SERVICE BULLETIN**15-T4-74**

DATE: 09/09/2015

MODELS CONCERNED: 42 XRD Rear discharge Decks

The Alternative Pulley and Drive Belt Recommendation

Figure 1

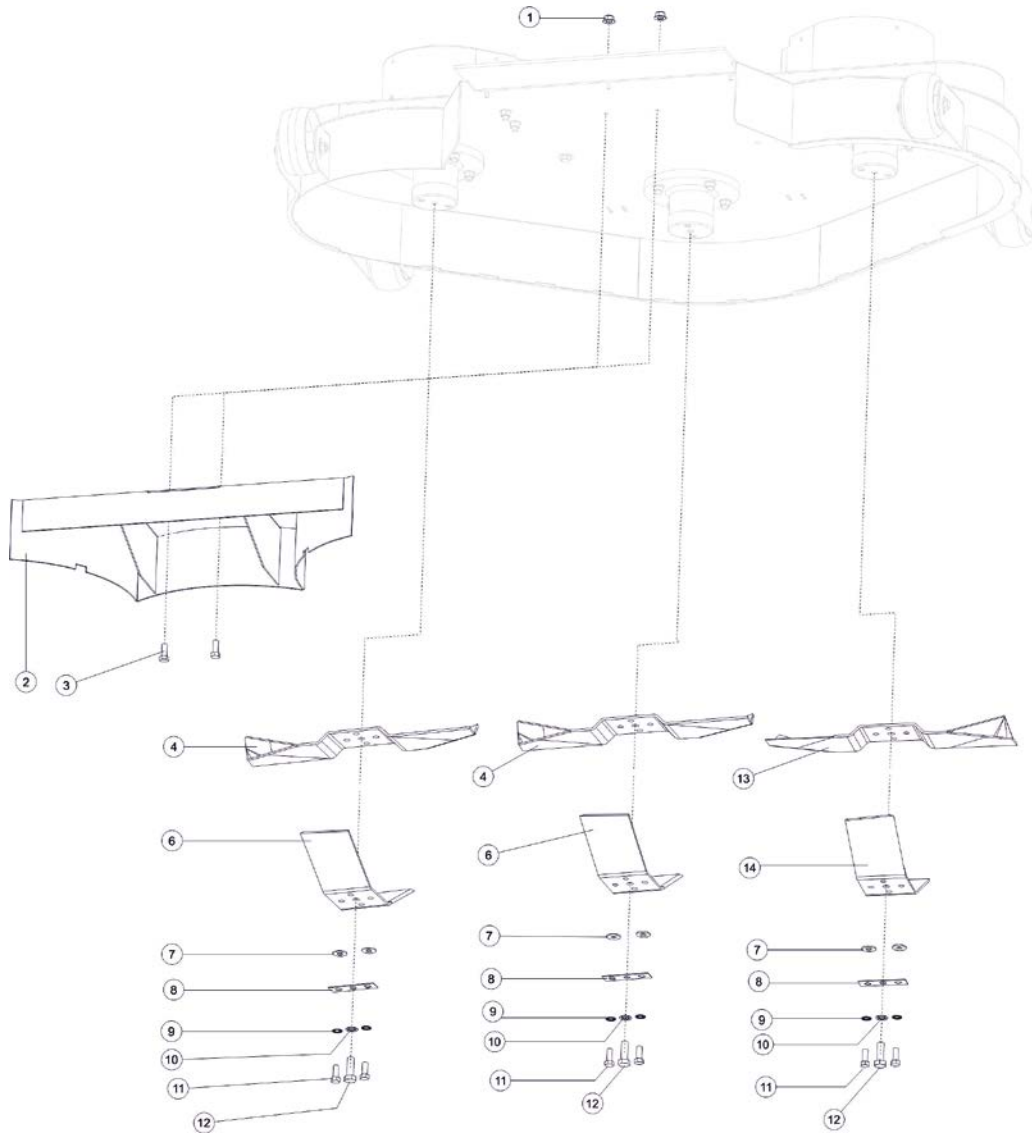
- Notes:
- (i) Ensure the locking strips (fig.1, No.8) are located in the correct position.
 - (ii) The cutting blades need to be replaced to ensure the mulching blades are securely fitted.
 - (iii) Ensure the torque settings are correct on the blade bolts – as follows:

Fig1, No 11 - M8 bolts = 25Nm (+/- 5%) Fig1, No 12 – M10 bolts = 51Nm (+/- 5%)

Figure 2

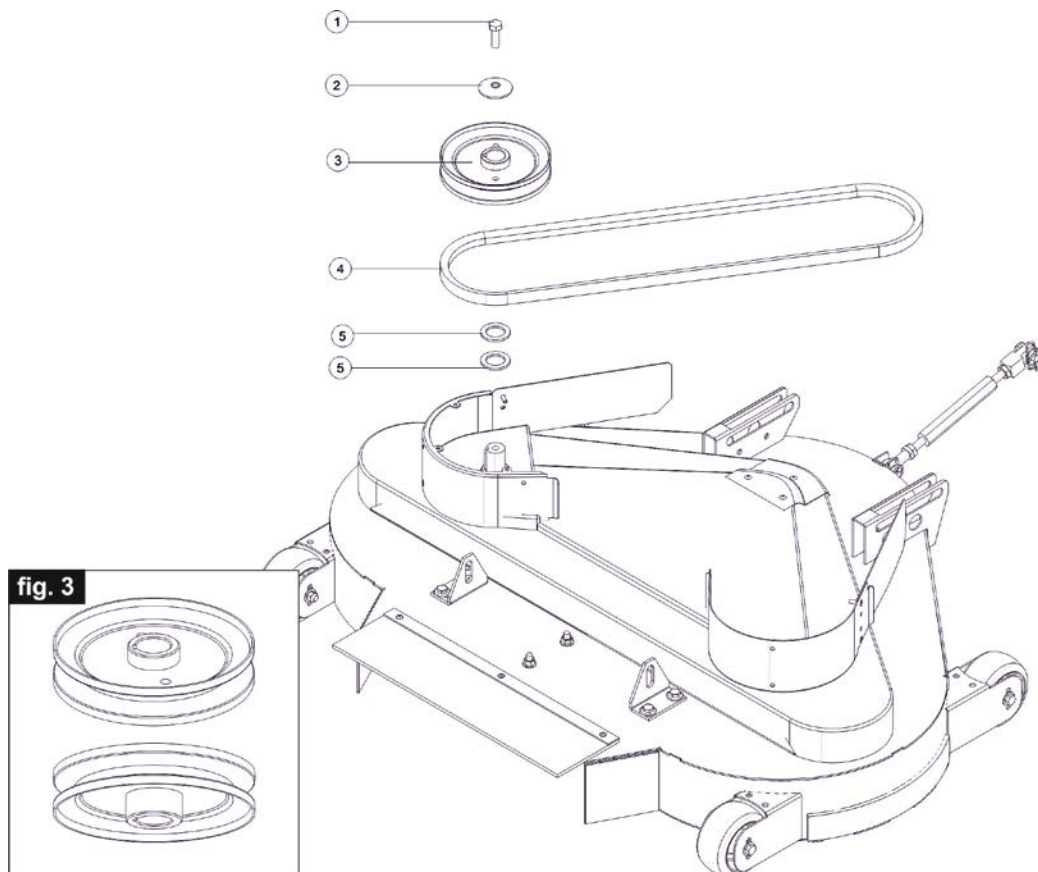
This bulletin replaces bulletin 15-T4-72. In this update the drive belt is changed from B57 to B58. The longer (B58) belt allows the deck to sit correctly and offers more adjustment.

The belt and pulley kit is assembled as shown in parts list figure 2. These kits should only be assembled by properly trained persons.

- Notes: (i) The belt tension must be checked after the kit has been fitted.
(ii) Ensure orientation of drive pulley (No. 3) is correct – larger boss facing down (see fig. 3)

1	02886000	M10 X 30 S/SCREW BZP
2	08819901	DOME WASHER 3/8 X 1 3/4 X 1/8
3	209044300	5 3/4" (146mm)DK DRIVE PULLEY 42" HGM 2050 ONLY
4	22870100	B58 BELT
5	549011500	Pulley Shim
